**City of Napoleon**  
**2023 Palmer Ditch Pumping Station Improvements**  
**Bid Addendum No. 2**  
**July 3, 2023**

Addendum No. 2 consisting of **6 pages**, issued to active plan holders on record.

Plan holders on the City of Napoleon 2023 Palmer Ditch Pumping Station Improvements are hereby notified of the following amendments to the Contract Documents. This Addendum is hereby made a part of the Contract Documents and shall be acknowledged by responsive Bidders within Page BF-1 of the Bid Form.

# Discharge Check Valves

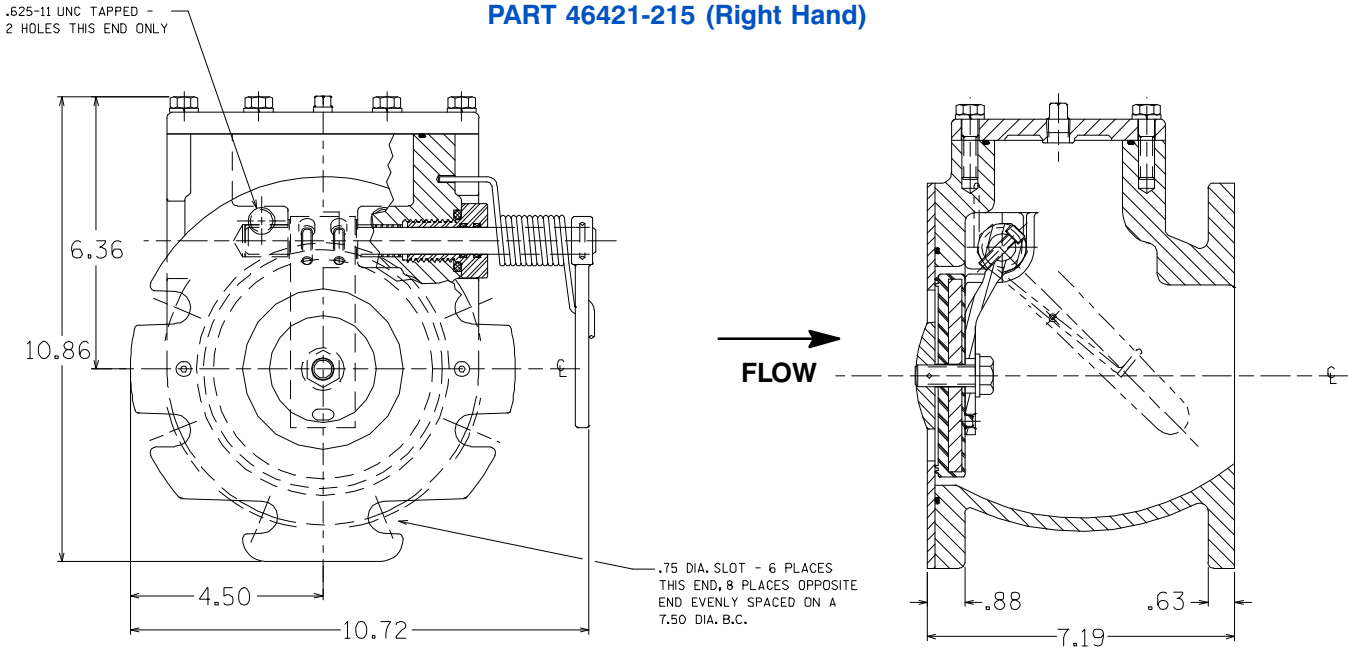
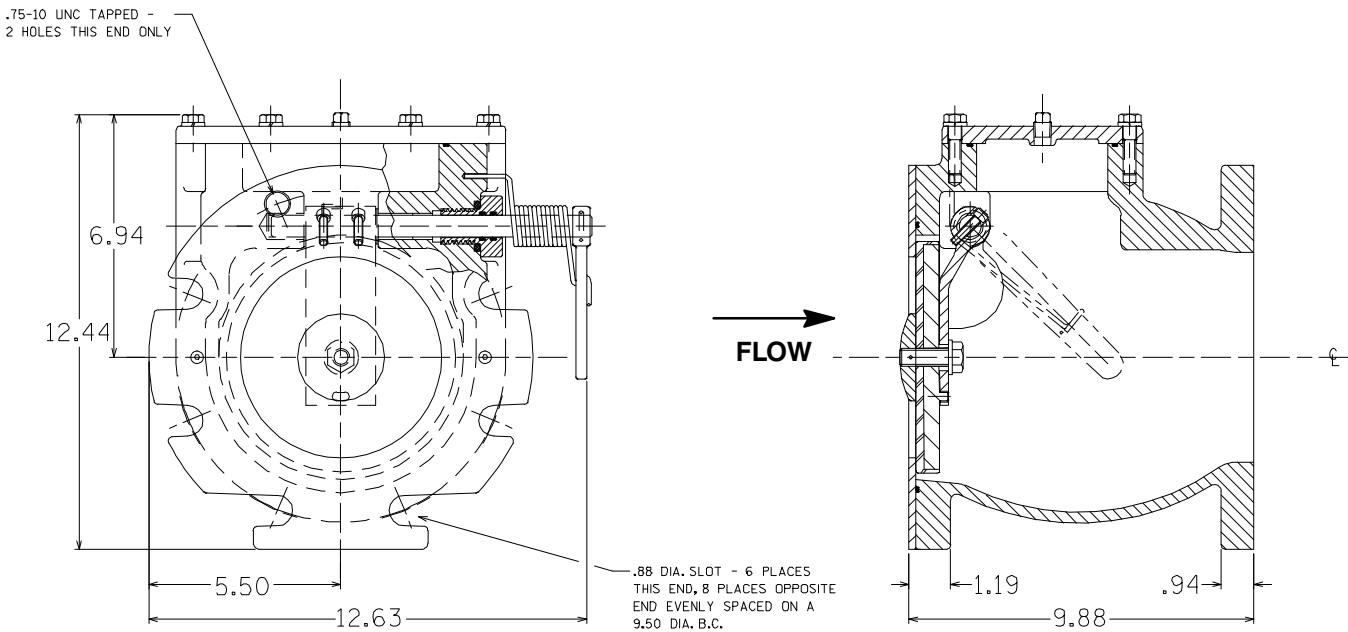
- THREE (3) 6” CHECK VALVES AND THREE (3) 6” DIA. X 7” LONG TAPPED SPOOL PIECES, INCLUDING GASKETS AND STAINLESS STEEL BOLTS AND NUTS. COPIES OF SPEC SHEETS FOR THE CHECK VALVES AND SPOOL PIECES ARE PROVIDED WITH ADDENDUM NO. 1.
